**From:** James Lyon  
**Sent:** Saturday, January 2, 2021 11:17 PM  
**To:** Jennifer Armer; Joel Paulson  
**Cc:** Rick Rutte; Kelly Luoma; Babak Homayouni; Bahar Masarati  
**Subject:** Re: New design for 15 Loma Alta Avenue

EXHIBIT 19

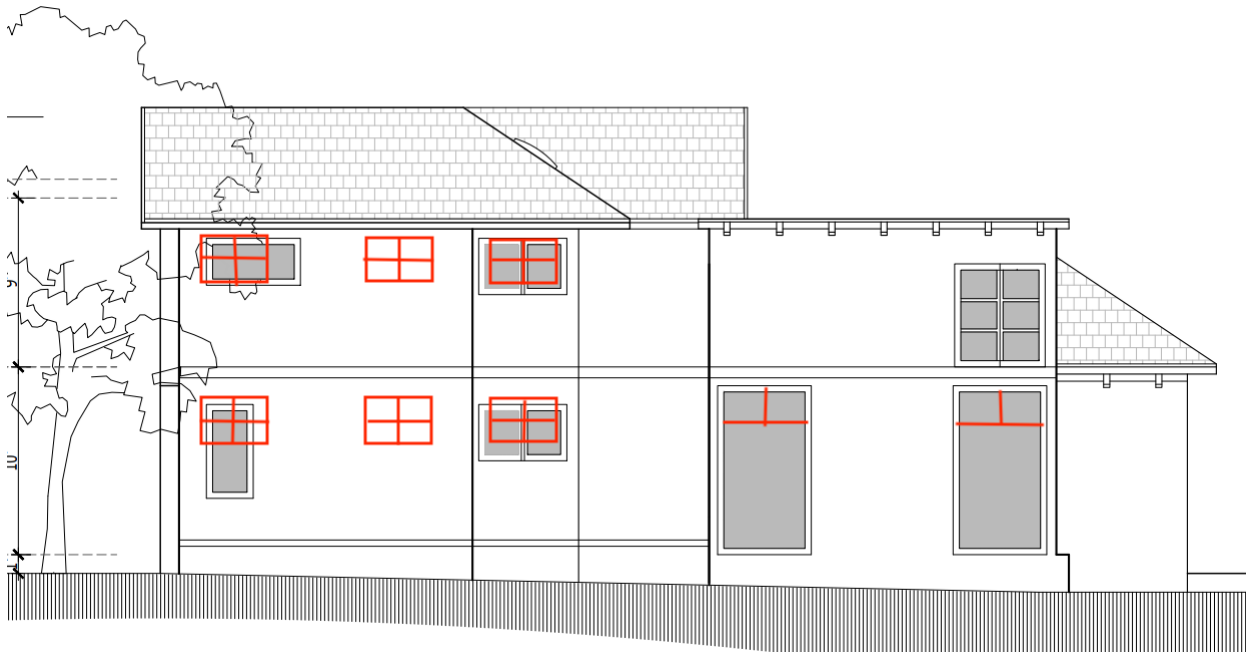
1. Consistent lighting on doors and windows: The color renderings (sheet 3.4) has consistent lighting (preferred) on the Front and Panighetti Place elevation, while the line drawings (sheet A3.1a) do not (redlines capture the renderings)

2. Sheet A3.1a calls out a Plexiglass railing – I believe this is a remanent of the prior design and should be eliminate for the exterior elevations.
3. The Side Elevation fenestration is awkward and inconsistent with the Craftsman motif. A more consistent fenestration would be a multi-lighted high awning window to provide light and privacy to the two bedrooms and bathrooms. Further, some level of Craftsman lighting details at the top of the large view windows would tie them into the overall design.

4. There are inconsistencies between the floor plans and elevations. As example - the floor plan (living room) and front elevation shows a chimney, but the chimney is not shown on the side elevation.
5. The sloped roof overhangs are inconsistent depth. The Side Elevation overhang is much larger (2'10" from the roof plan or greater based on wall articulation) than any other overhang and appears quite awkward.
